# MB90595/595G -

### Addendum, MB90595 Datasheet (DS07-13705-5E)

This is the Addendum for the Datasheet DS07-13705-4E of the MB90595/595G microcontroller series. It describes all known discrepancies of the MB90595/595G microcontroller series datasheet.

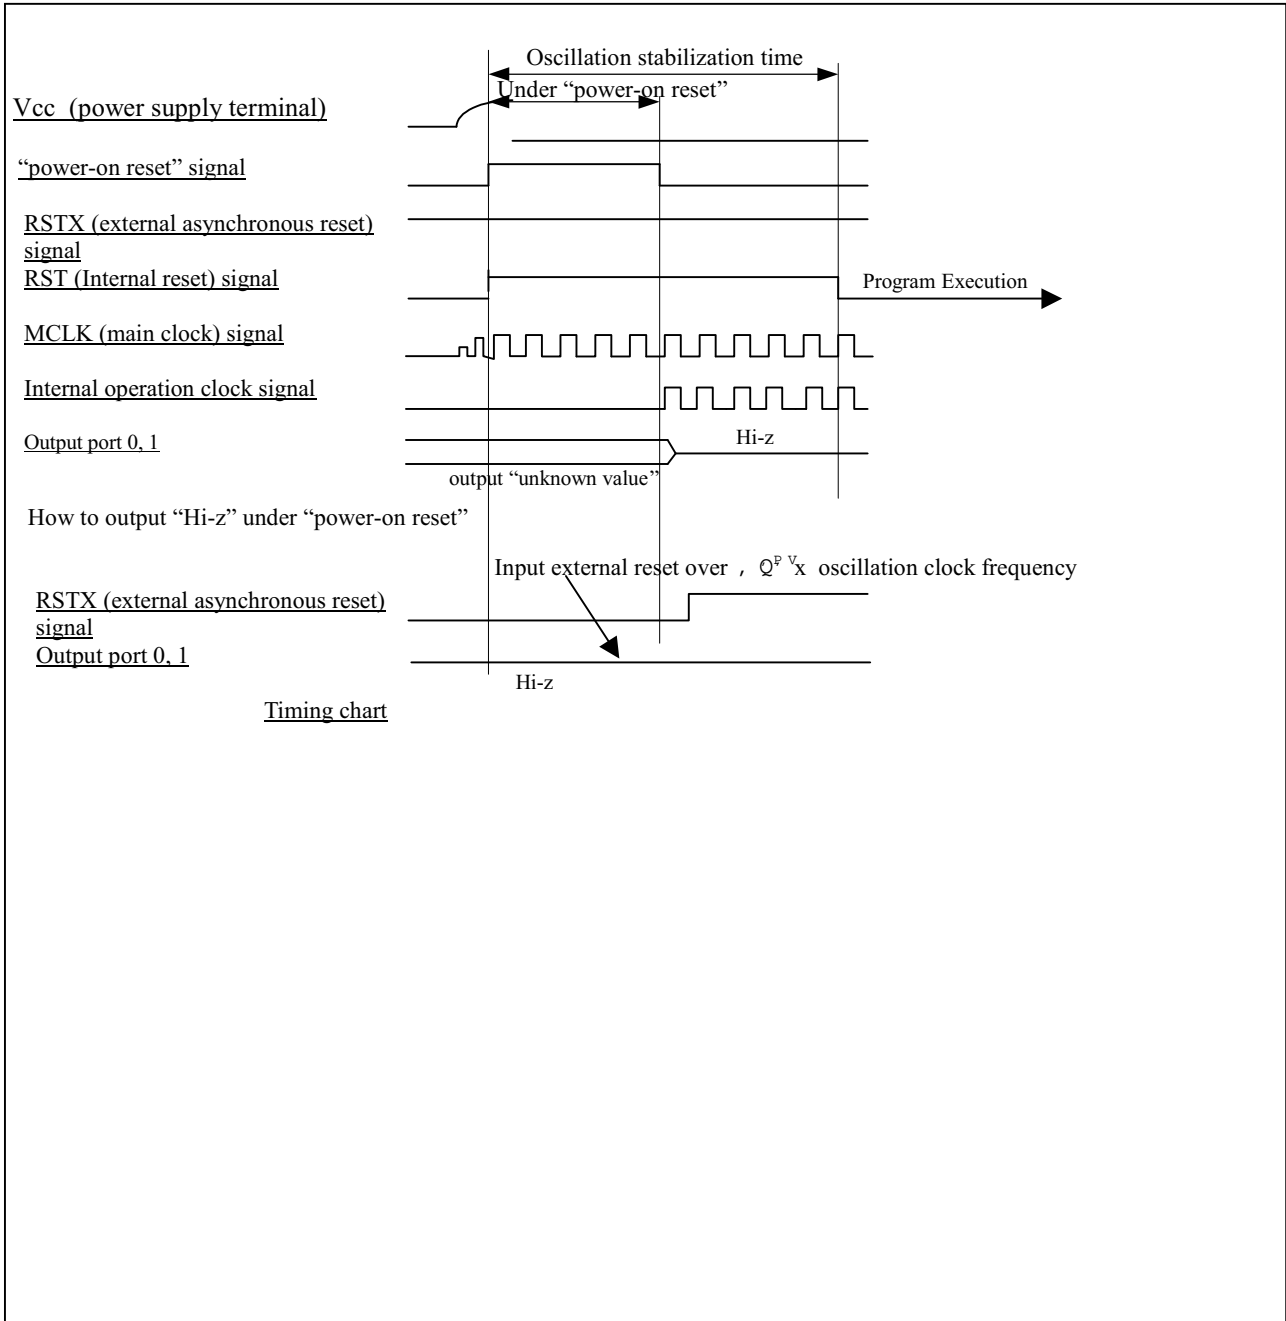
During testing it has been found that some port pins may enter an undefined state during power on. By asserting RSTx during the power on reset ( $2^{17}$  cycles of main clock) port pins can be forced to high impedance.

1. The following Ports will output a High Impedance (Hi-z) at the terminal when the power supply is turned on when PONR and RSTX = 1 (RSTx not asserted):

P20 - P45, P50 - P67, P90 - P95

2. The following ports can be forced to high impedance state (Hi-z) during PONR if RSTX is asserted during power on ( $2^7$  cycles of main clock) or with the End of POMR and the Start of the internal clock

P00 - P03, P16 - P17, P46 - P47, P70 - P87

3. The following Ports will output an High-Z with the End of PONR and the Start of internal clocks. RSTx does not force the pins to High-Z during power on.

P04 - P15

The following diagram shows the timing chart in detail.

Under “power-on reset”  $2^{17}$  x oscillation clock frequency  
 (8.192ms in case of oscillation clock frequency = 16MHz)

Waiting time to be stabilized oscillation  $2^{18}$  x oscillation clock frequency  
 (16.384ms in case of oscillation clock frequency = 16MHz)
